South Texas Project Electric Generating Station P.O. Box 289 Wadsworth, Texas 77483

April 29, 2010  
U7-C-STP-NRC-100093

South Texas Project  
Units 3 and 4  
Docket Nos. 52-012 and 52-013  
Response to Request for Additional Information

Attachments 2 through 7 are revised or supplemental responses to NRC staff questions included in Request for Additional Information (RAI) letter numbers 289, 299 and 302 related to Combined License Application (COLA) Part 2, Tier 2, Sections 3.7 and 3.8. References 1, 2 and 3 provided the original response to the following RAI questions:

**New COLA Figures 3H.6-11d through 3H.6-11L**

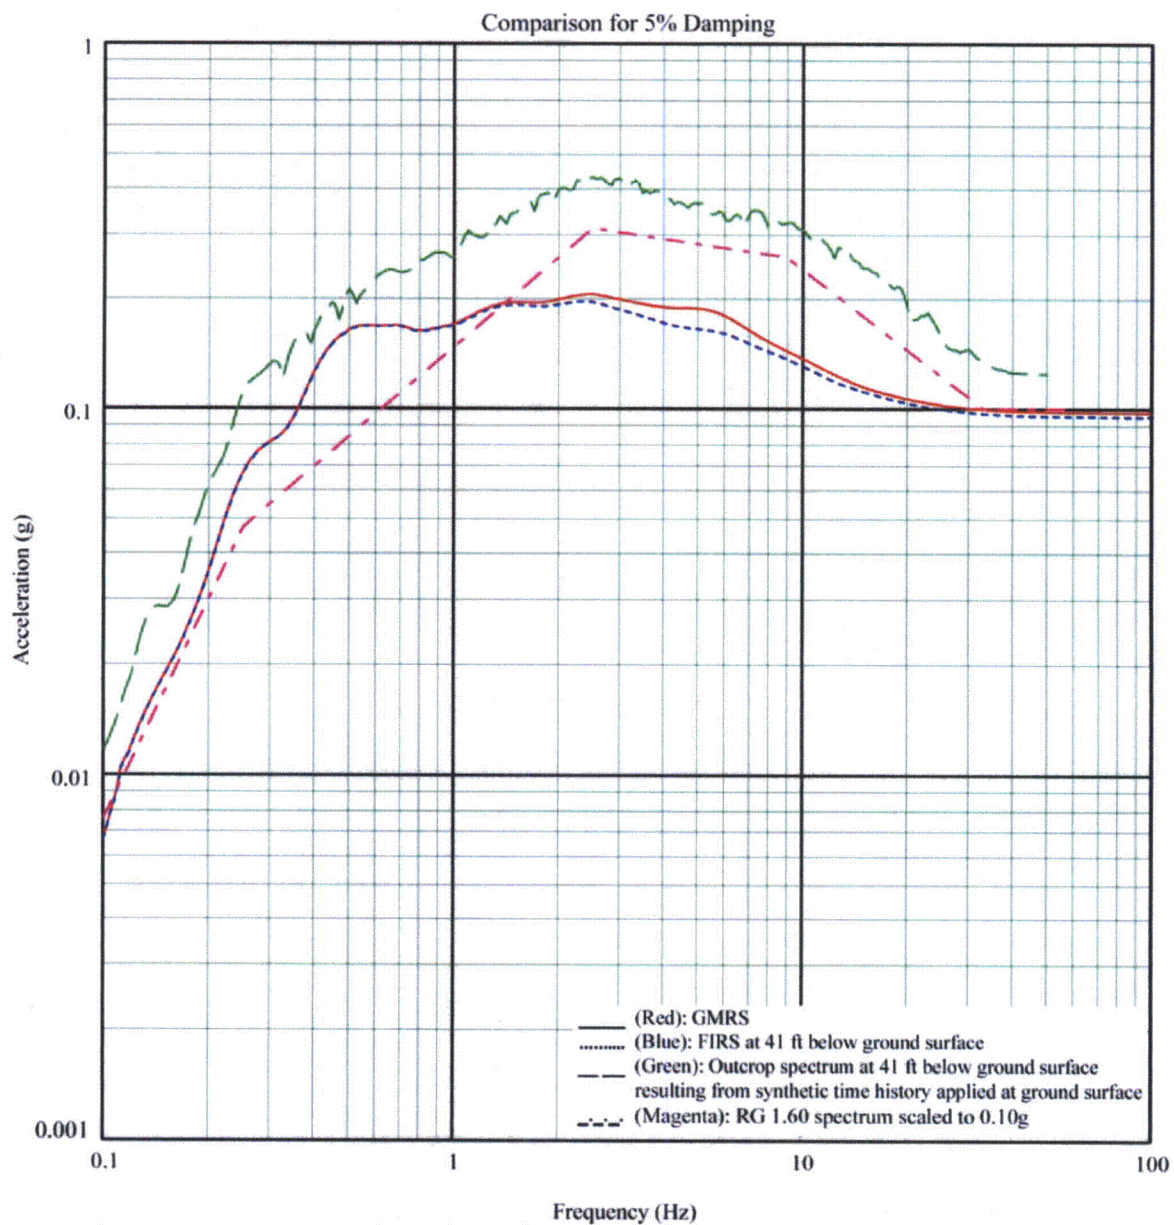
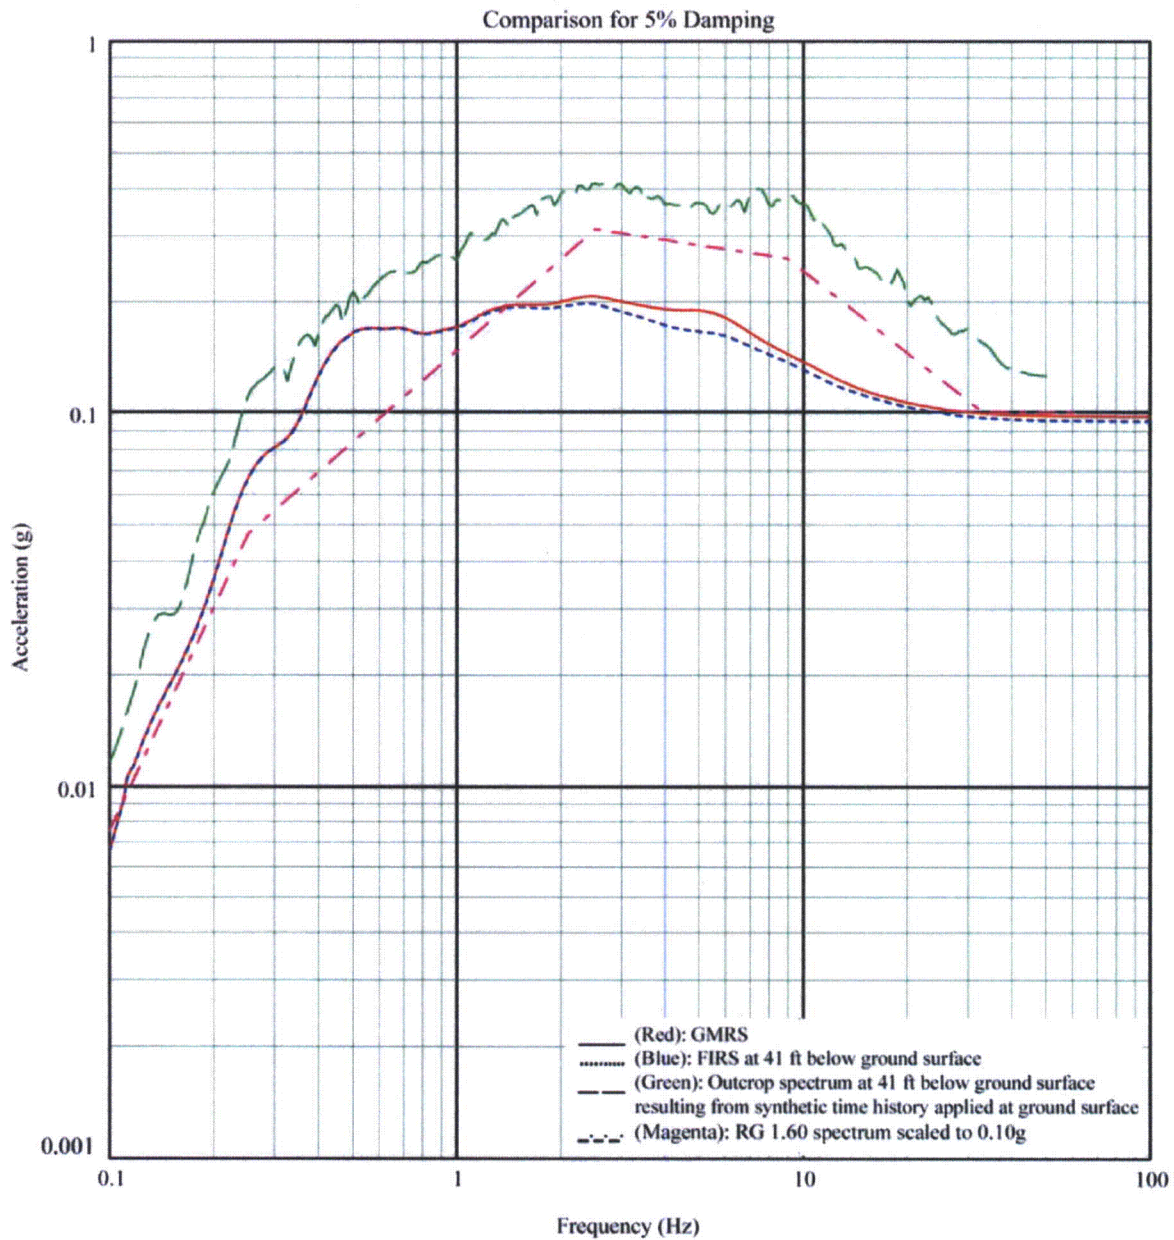
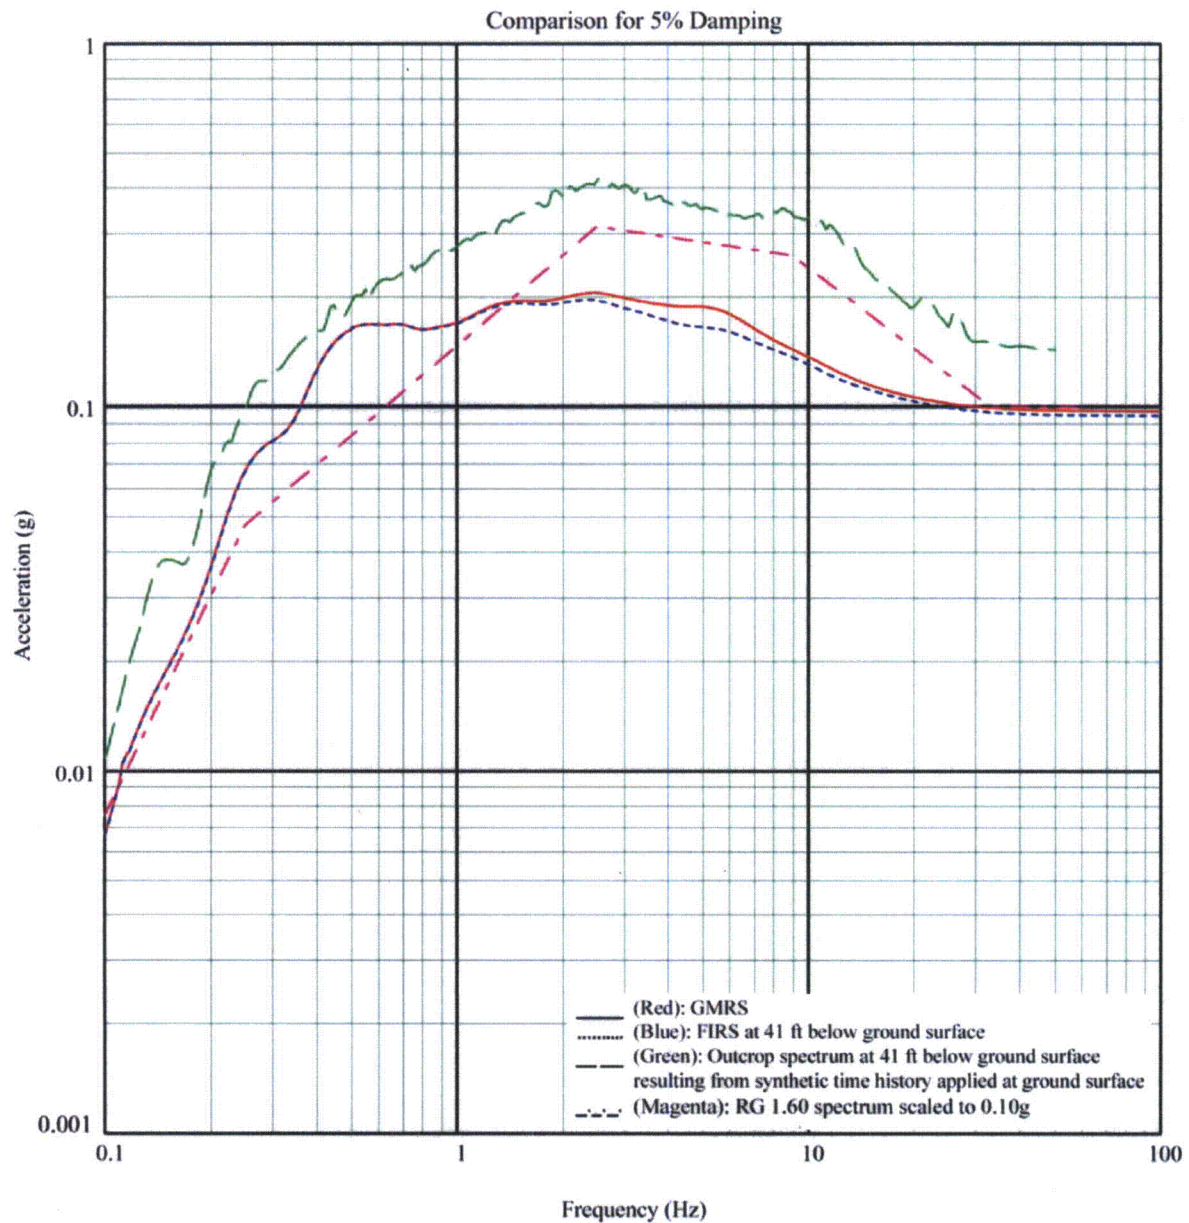
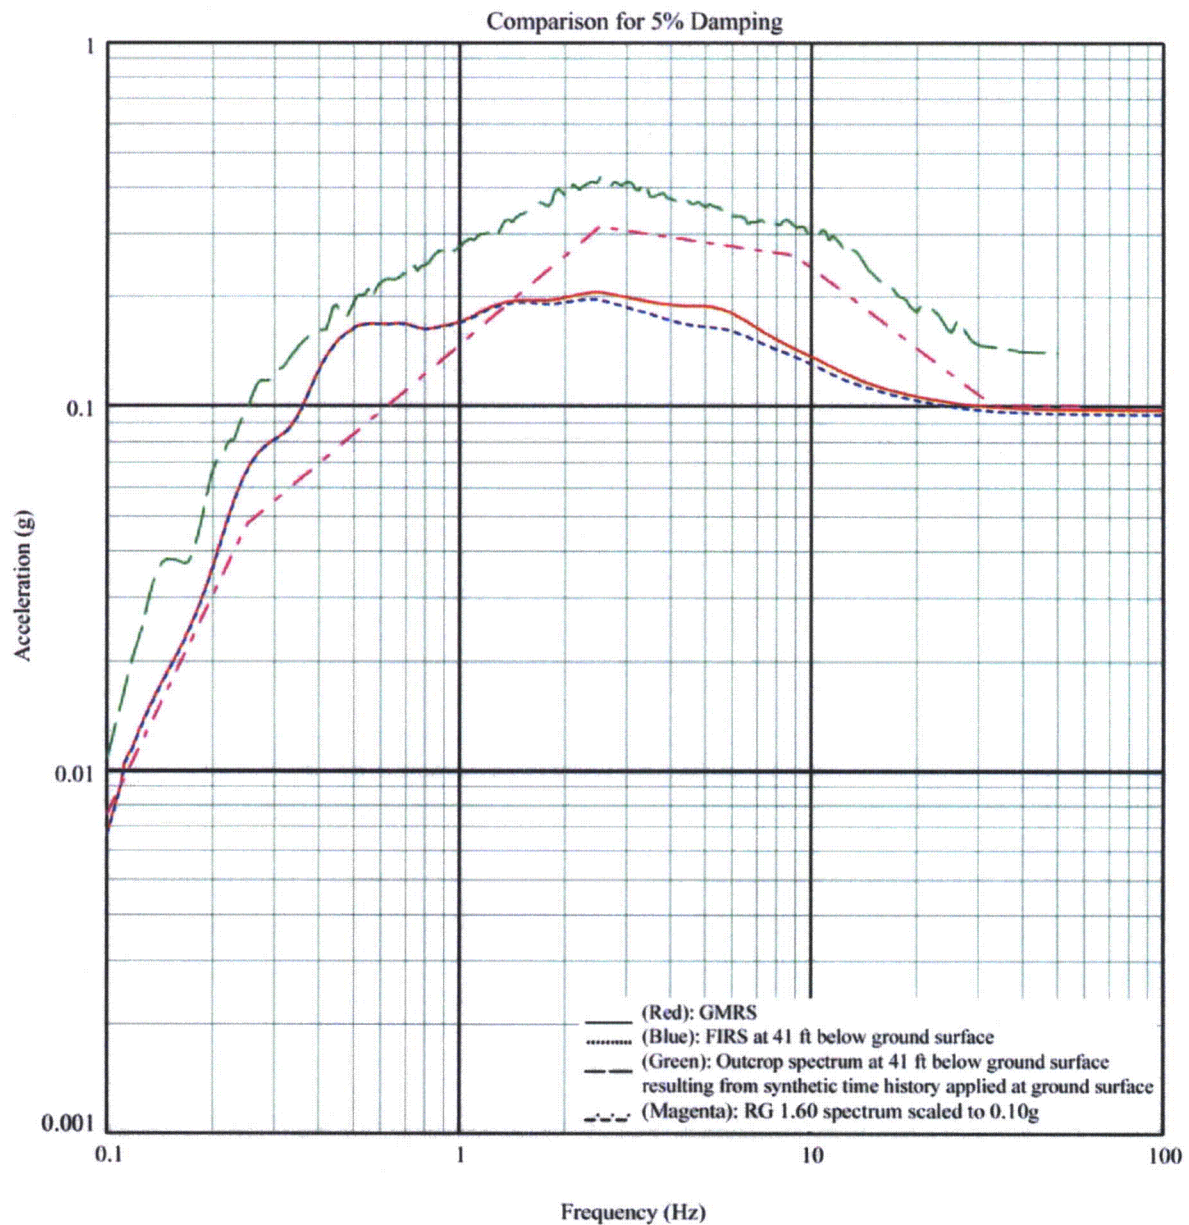
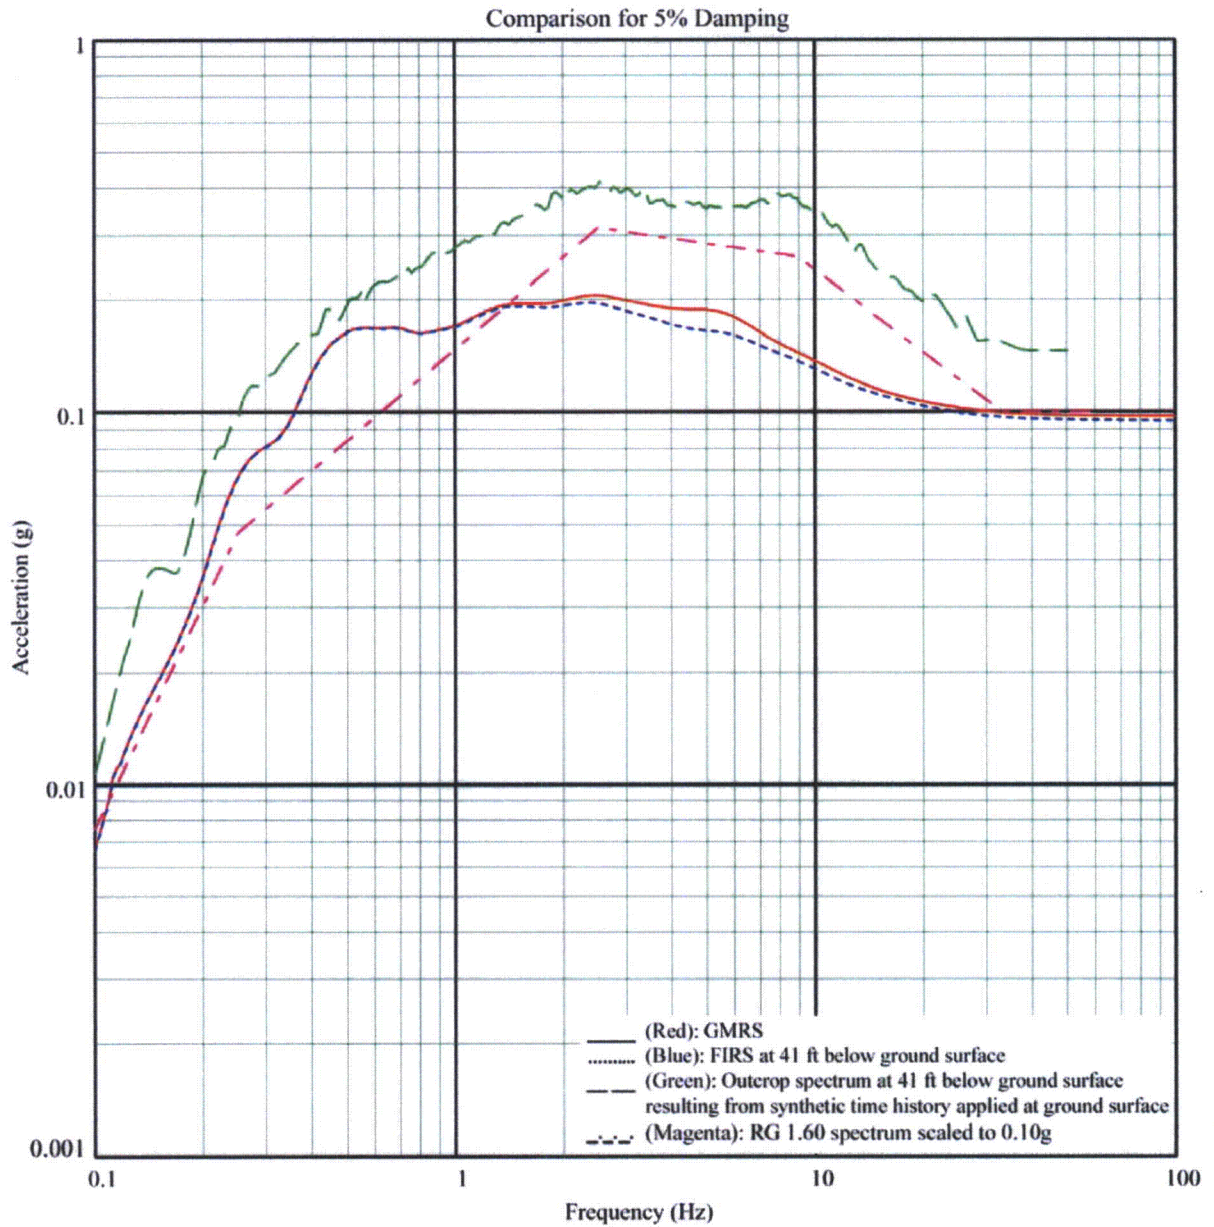
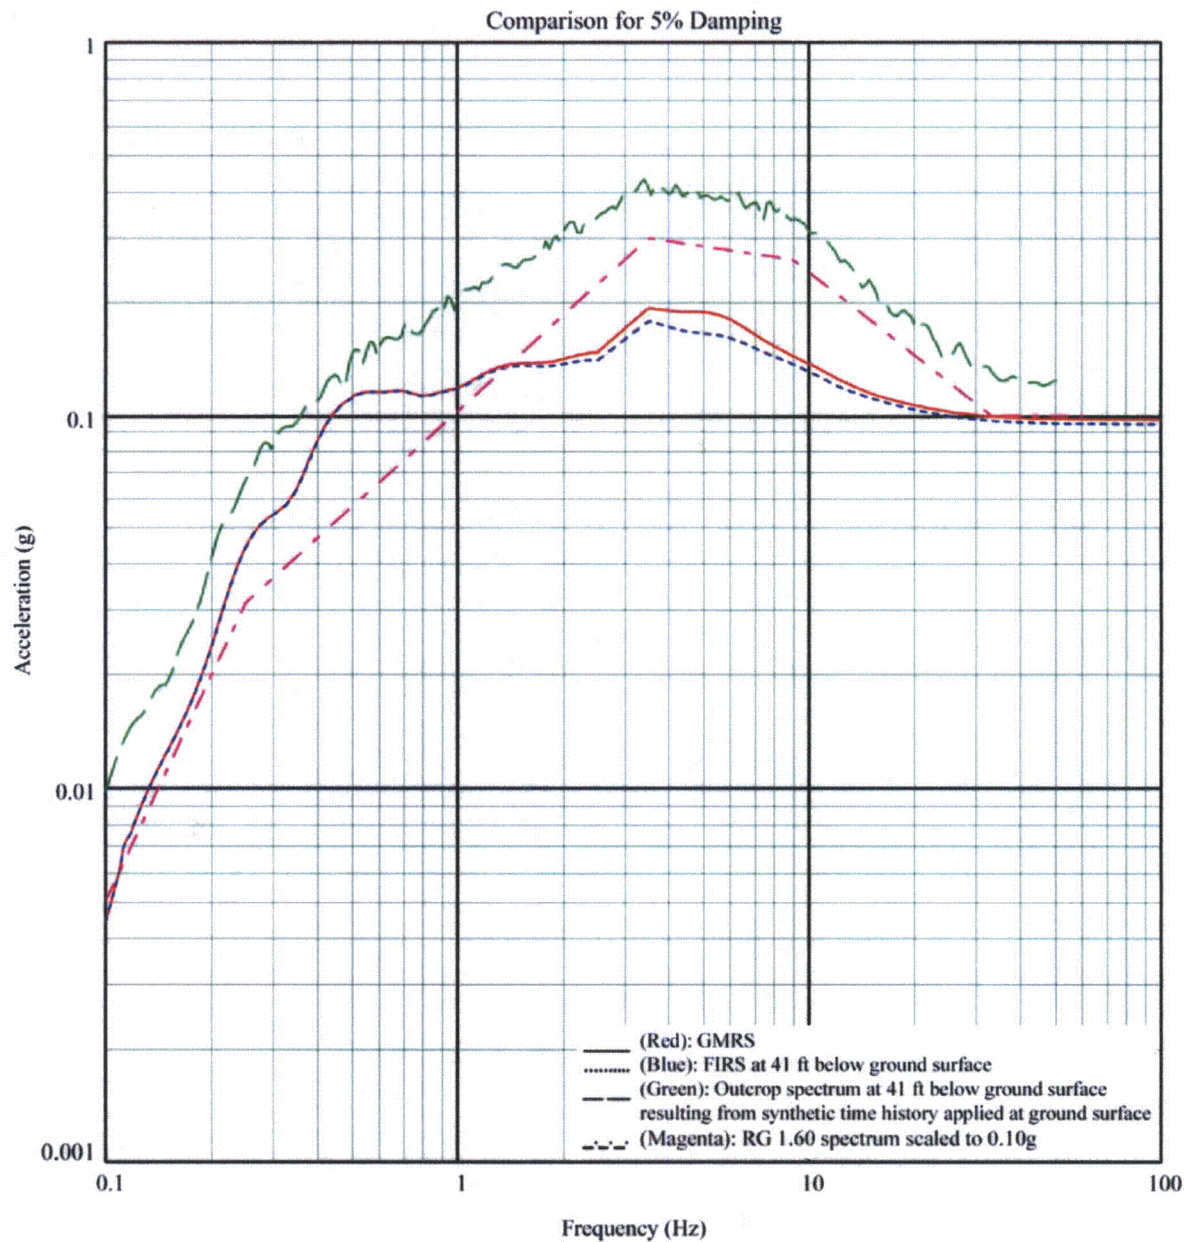
In response to RAI 03.07.01-6, the applicant referred to COLA Part 2, Tier 2, Section 3A.17 for description of the supporting media, dimensions of the structural foundation, and total structural height for the Reactor Building (RB) and Control Building (CB). However, the referenced section does not include the requested information for the Diesel Generator Fuel Oil Storage Vaults (DGFOVS) which is listed as Seismic Category I structure in Revision 3 of the FSAR Section 2.5S.4.10.2. As such, the applicant was requested to provide information on supporting media for DGFOVS. Since the shear wave velocity parameter of the subgrade material (soil or backfill) supporting this structure may be less than 1000 fps, the applicant is also requested to provide quantitative results of the reconciliatory site specific seismic analysis (with appropriate consideration of dynamic soil or backfill properties) addressing the potential impact on FIRS, SSI, settlement calculations, and structural design concerning DGFOVS.

3. In response to RAI 03.07.01-6, Item 3, the applicant states that, "The seismic site response analysis was conducted, as described in Section 2.5S.2.5, using P-SHAKE to develop Ground Motion Response Spectrum (GMRS). ...." No reference to P-SHAKE program was found in Section 2.5S.2.5 of Revision 3, and no proposed FSAR markup is provided for future incorporation. As such, the applicant is requested to clarify whether P-SHAKE program has been used to develop GMRS and strain-compatible soil properties, as described in Section 2.5S.2.5, and if so, how P-SHAKE program performs site-response analysis (e.g. deterministic or probabilistic method, etc.). The applicant is further requested to clarify whether P-SHAKE program was also used to perform deconvolution of the SSE design motion specified at the freefield ground surface to calculate the foundation motion for the Seismic Category I structures.

The comparison of response spectra (the minimum required 0.1g Regulatory Guide 1.60 spectra, the FIRS, and the deconvolved SHAKE outcrop spectra) at the foundation level of the DGFOVS is presented in Figures 3H.6-11d through 3H.6-11L, included in Enclosure 1. As can be seen from these figures, the deconvolved SHAKE outcrop spectra envelop the minimum required spectra and FIRS for the three sets of soil properties.

The comparison of response spectra (the minimum required 0.1g Regulatory Guide 1.60 spectra, the FIRS, and the deconvolved SHAKE outcrop spectra) at the foundation level of the DGFOVS is presented in Figures 3H.6-11d through 3H.6-11L. As can be seen from these figures, the deconvolved SHAKE outcrop spectra envelop the minimum required spectra and FIRS for the three sets of soil properties.

3. Add enclosed Figures 3H.6-11d through 3H.6-11L, and 3H.6-140 through 3H.6-208. Also, add Tables 3H.6-11 through 3H.6-13.
